**REGULAR MEETING OF THE UNITED LAGUNA HILLS MUTUAL
ARCHITECTURAL CONTROL AND STANDARDS COMMITTEE**

**Wednesday, January 17, 2018 – 9:30 a.m.
Laguna Woods Village Community Center Sycamore Room
24351 El Toro Road**

DATE: January 17, 2018
FOR: Architectural Controls and Standards Committee
SUBJECT: Conversion of Architectural File Drawings to CAD

DATE: January 17, 2018
FOR: Architectural Control and Standards Committee
SUBJECT: Variance Request: Mr. Ohsoon Chun of 105-C (San Sebastian, 7)
Extend Living Room onto Existing Patio

566 AVENIDA SEVILLA #B
REMODEL ATRIUM - RESIDENTIAL CONDO
as of 11/17/17

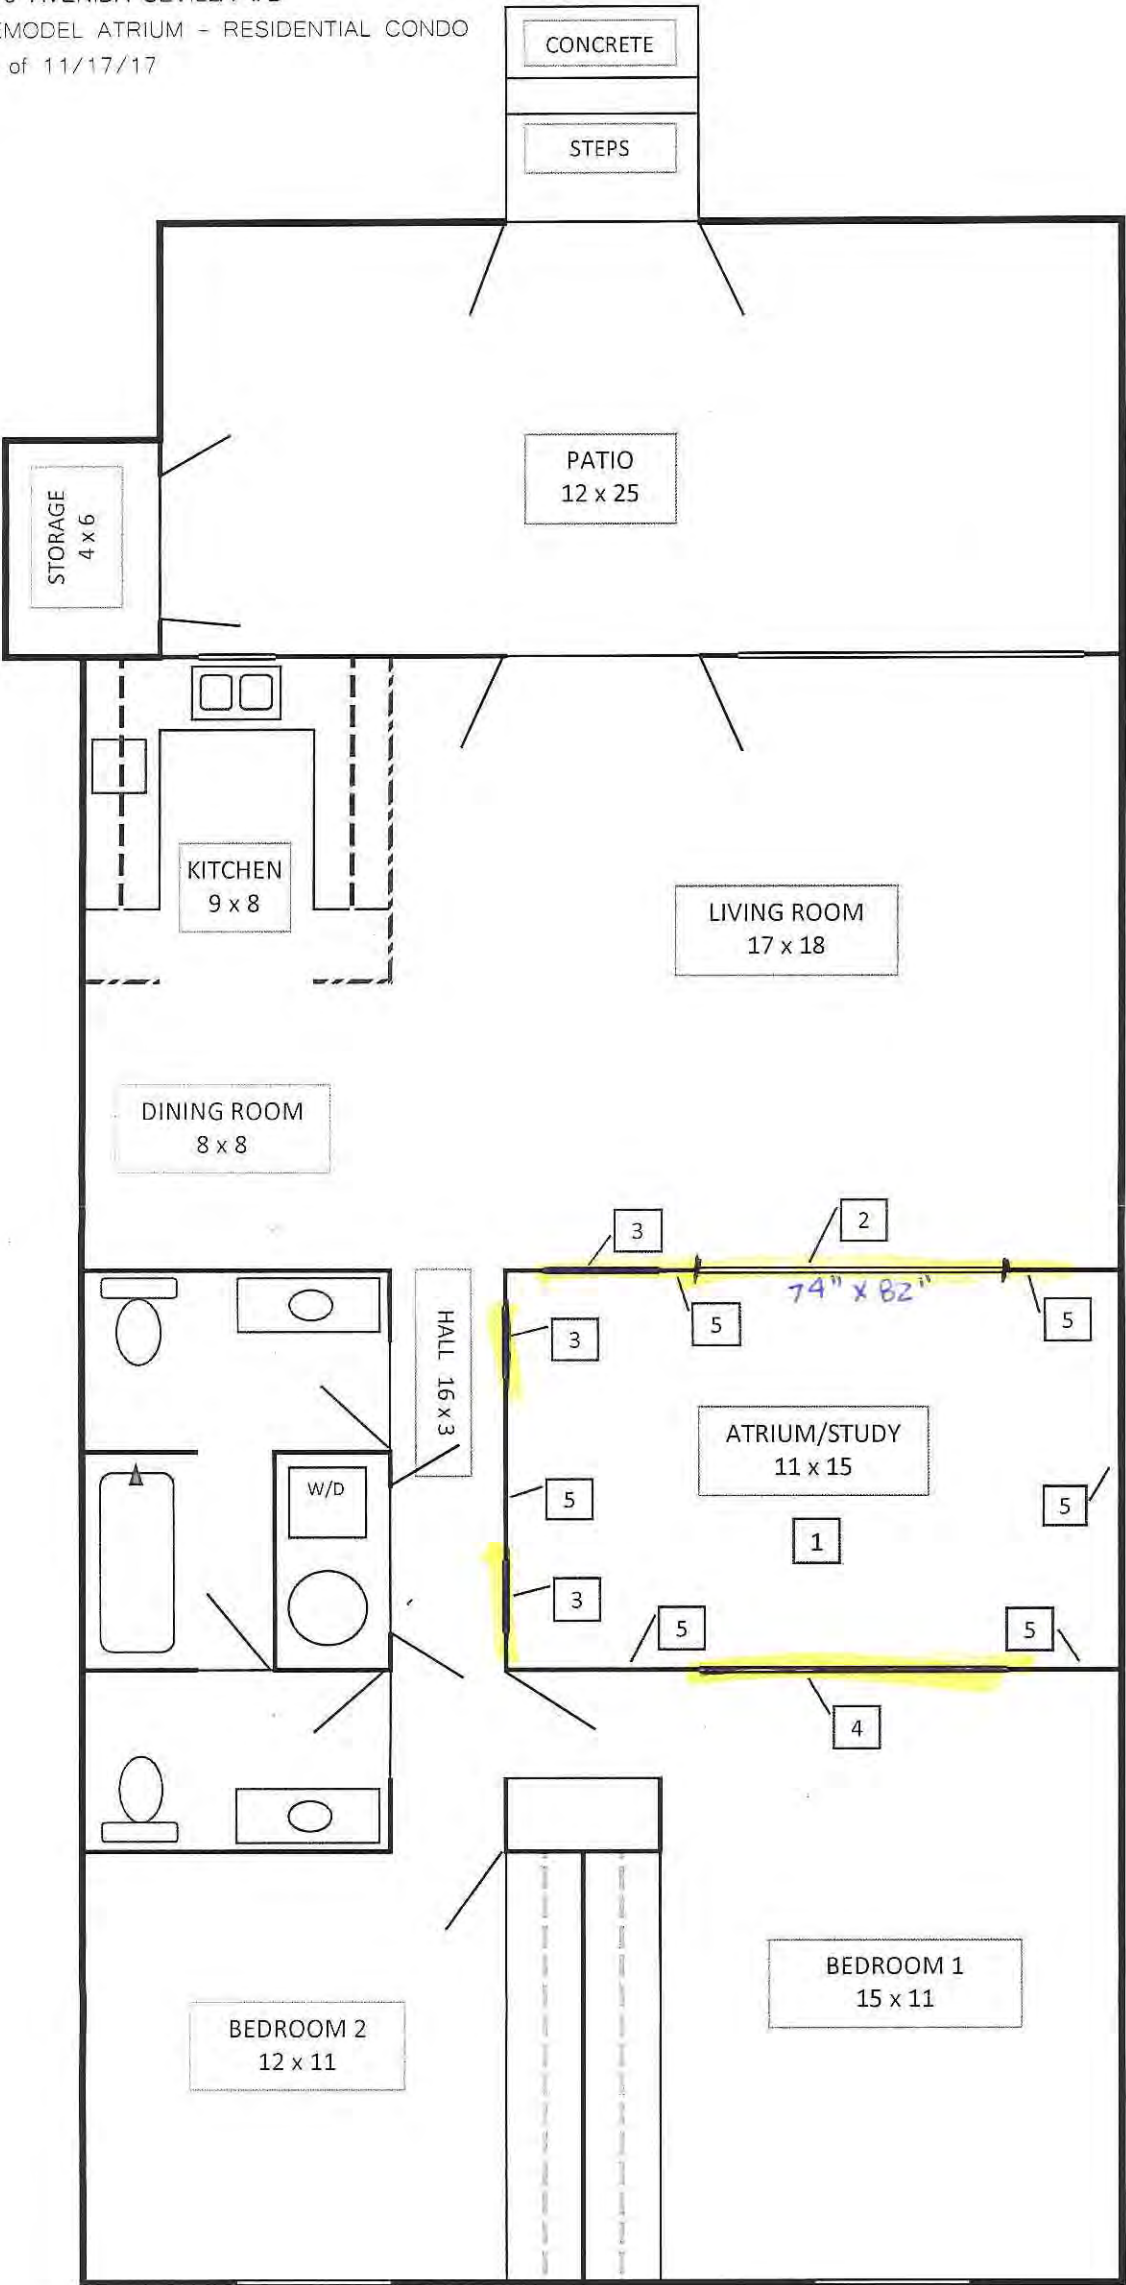
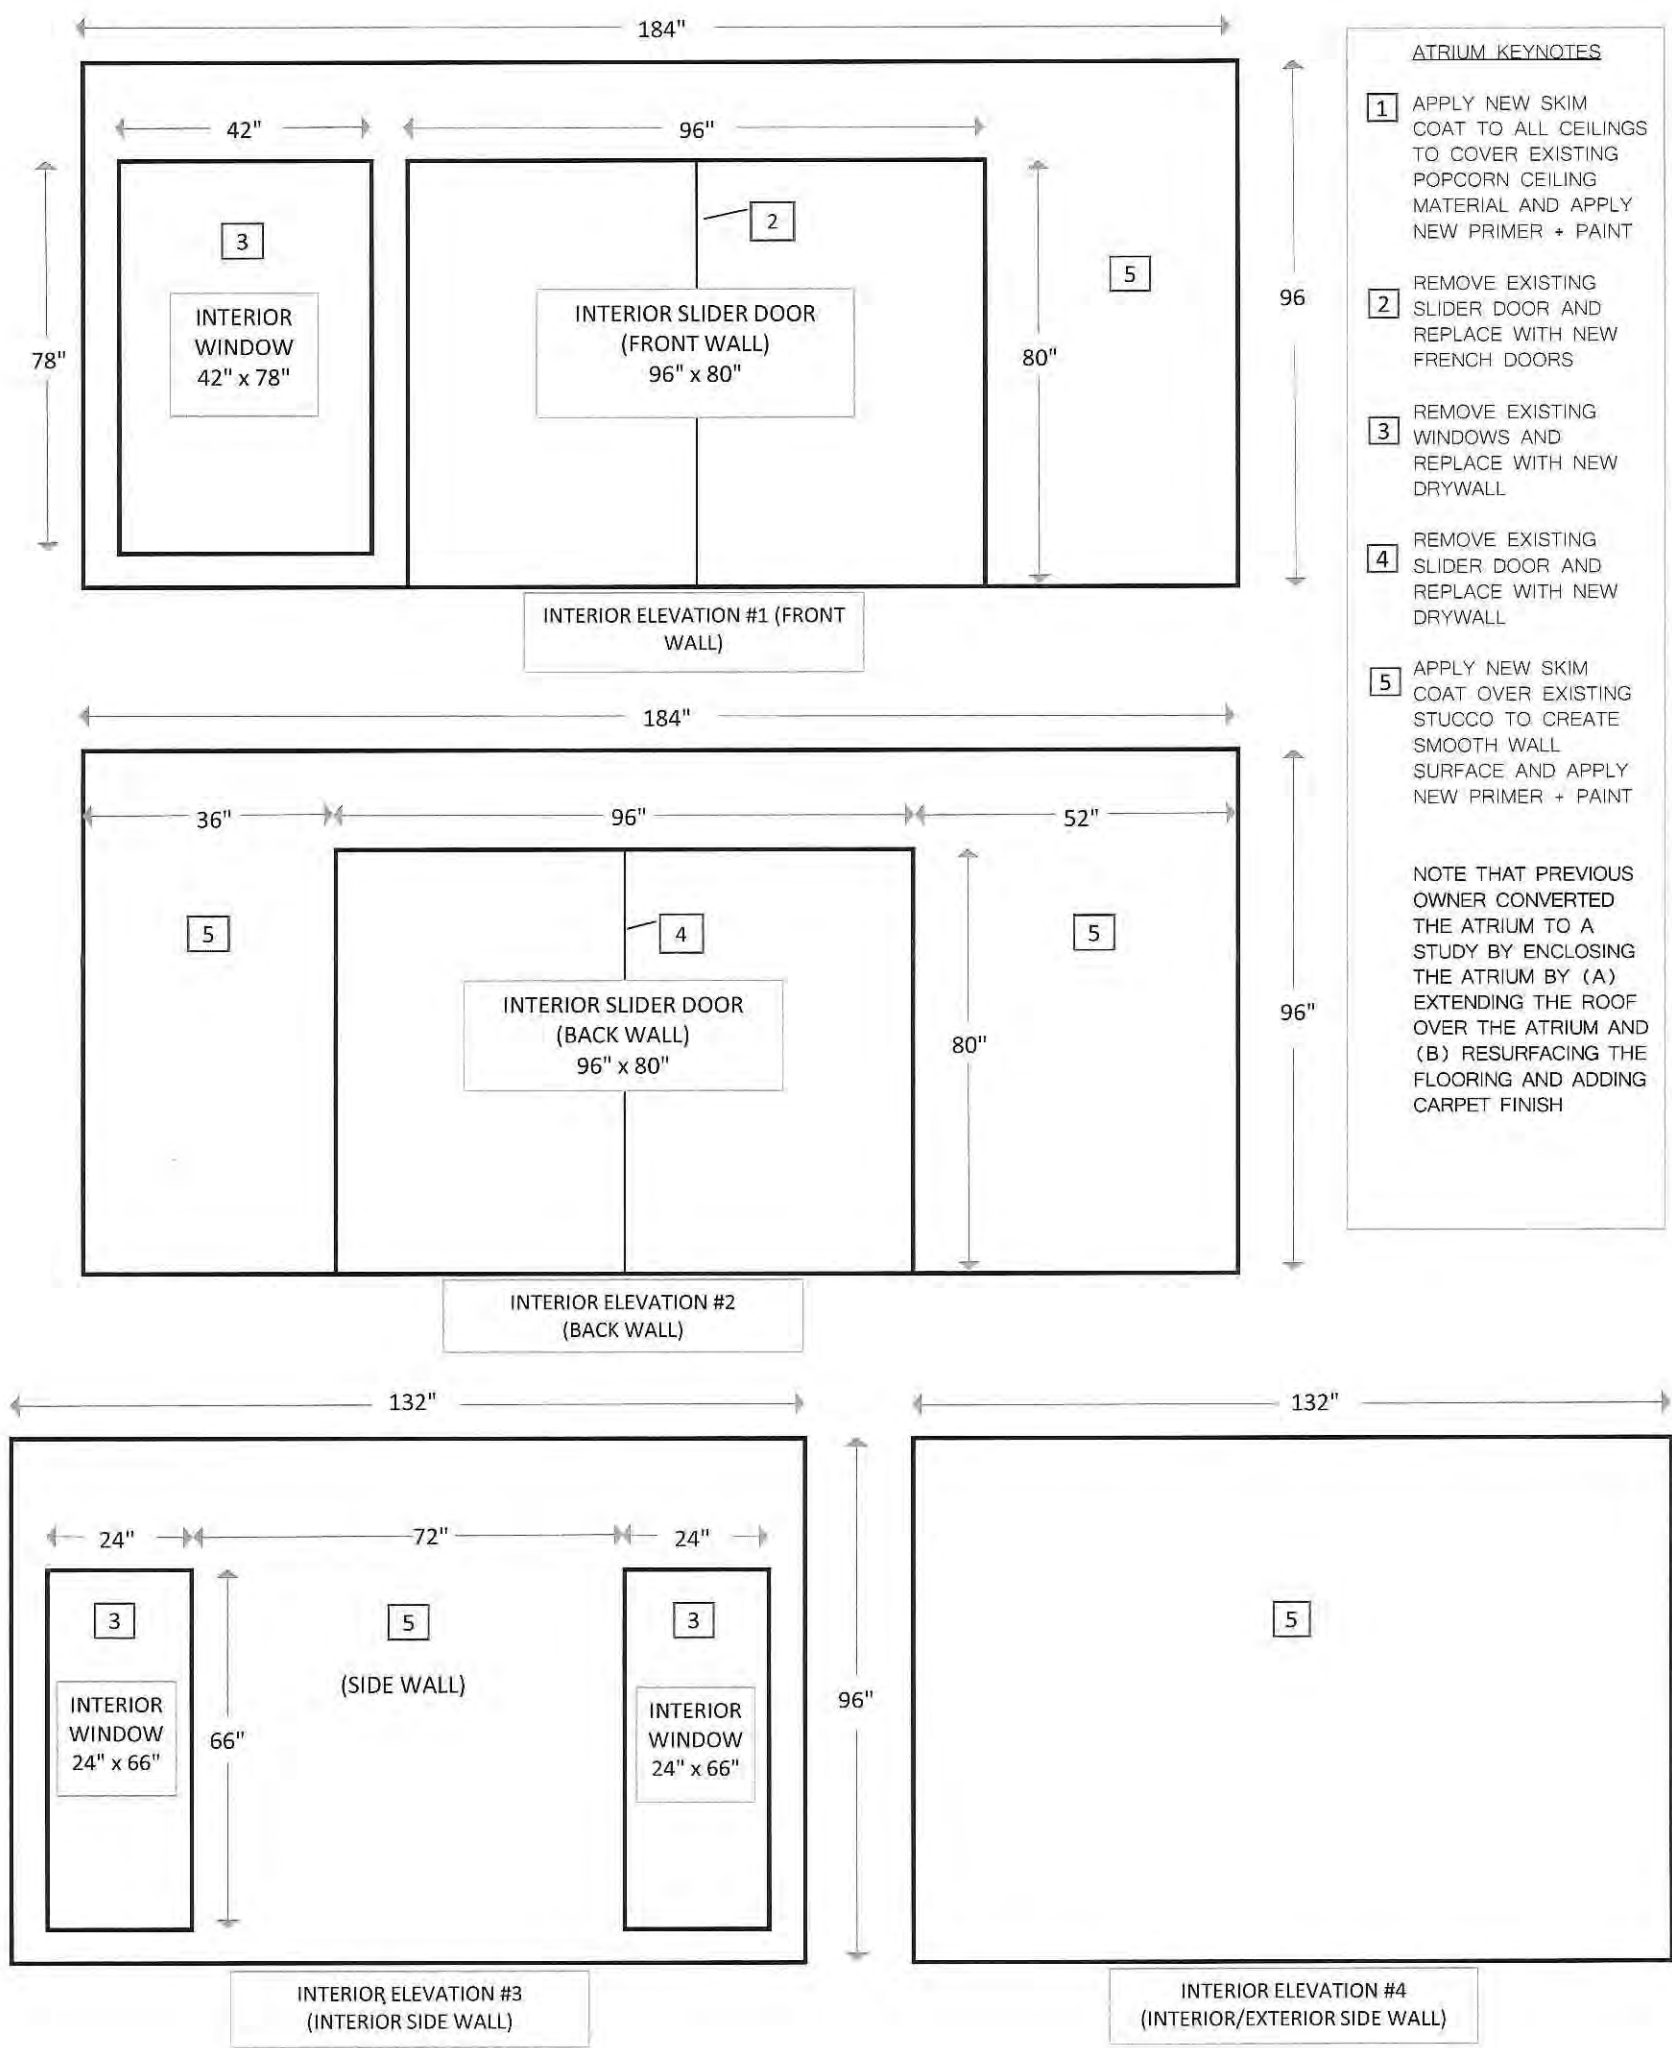
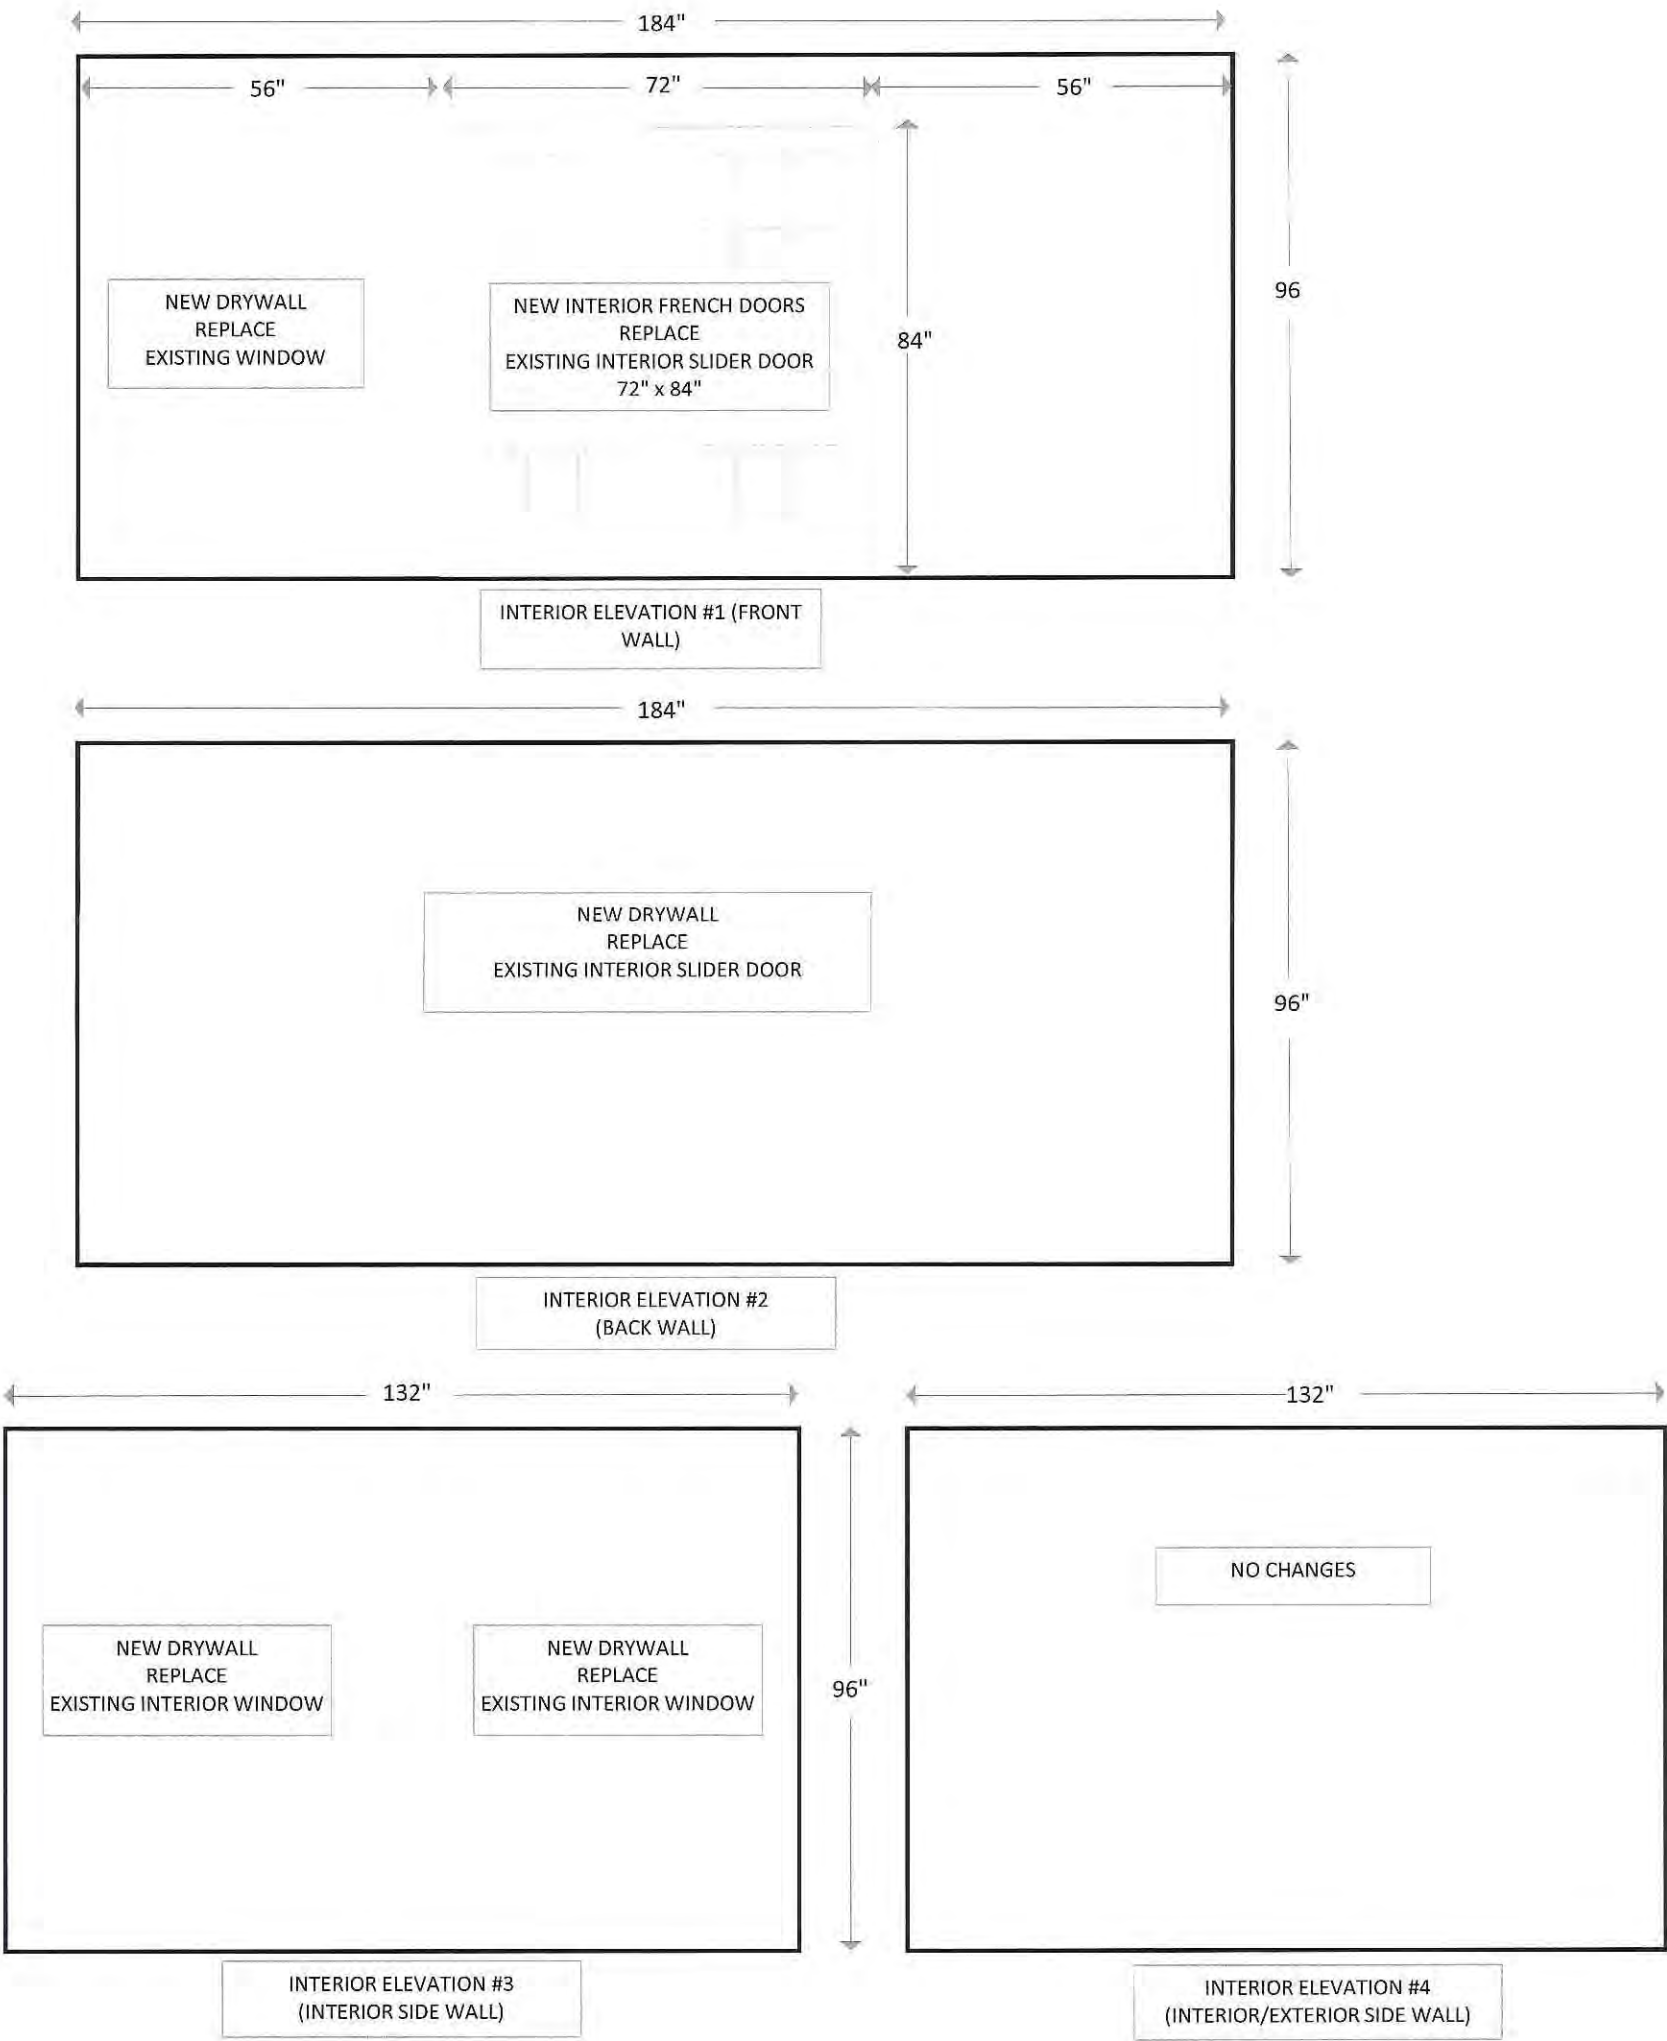
Mr. Lee proposes to enclose the atrium and create a study with a single entrance from the living room. To accomplish this he proposes to replace the existing sliding glass door that leads to the adjacent living room with a French door. The existing opening for the sliding glass door is ninety-four inches wide by eighty inches tall; the opening will need to be modified to install the proposed French door which is seventy-four inches wide by eighty-four inches tall.

Mr. Lee proposes to remove both existing windows that abut the hallway. Additionally he proposes to remove the window and the sliding glass door that borders the living room. All door and window removals will be patched back with drywall. He plans to skim coat the stucco in the atrium to provide a smooth texture to match the new drywall.

Staff recommends the Board approve the request to revise the existing atrium enclosed walls with the conditions as stated in Appendix A.
